FUEL TANK SUPPORT HDW

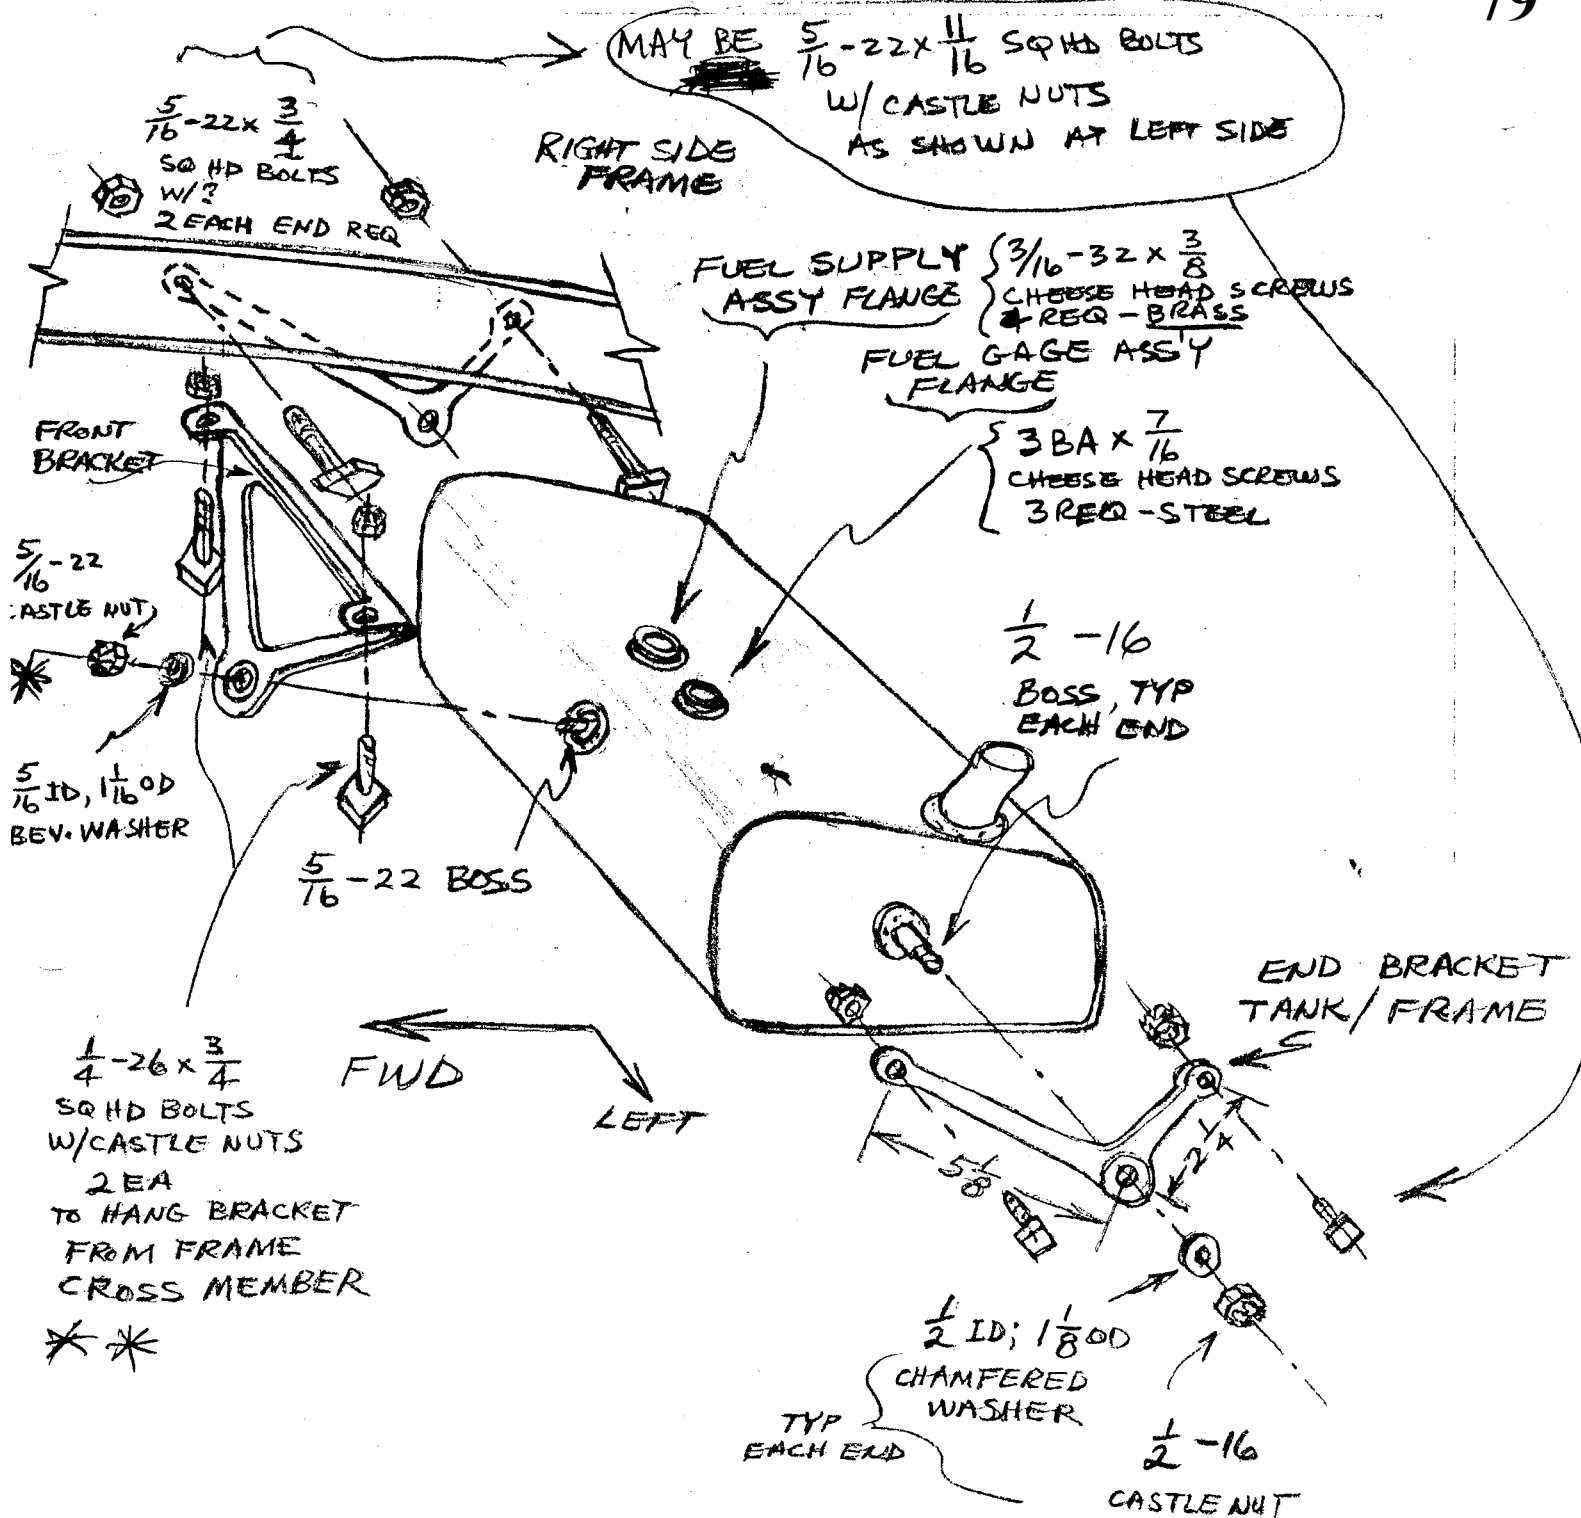
* RE-INSTALL W/REG HEX NUT - NO "HOLE" IN STUD ON FUEL TANK SO NO REASON FOR CASTLE NUT.

** THERE WERE NO $\frac{1}{4}$ -26 x $\frac{3}{4}$ BOLTS WITH HOLES FOR COTTER PINS IN MY PARTS
CAUS SO USED REG BOLTS & NUTS.
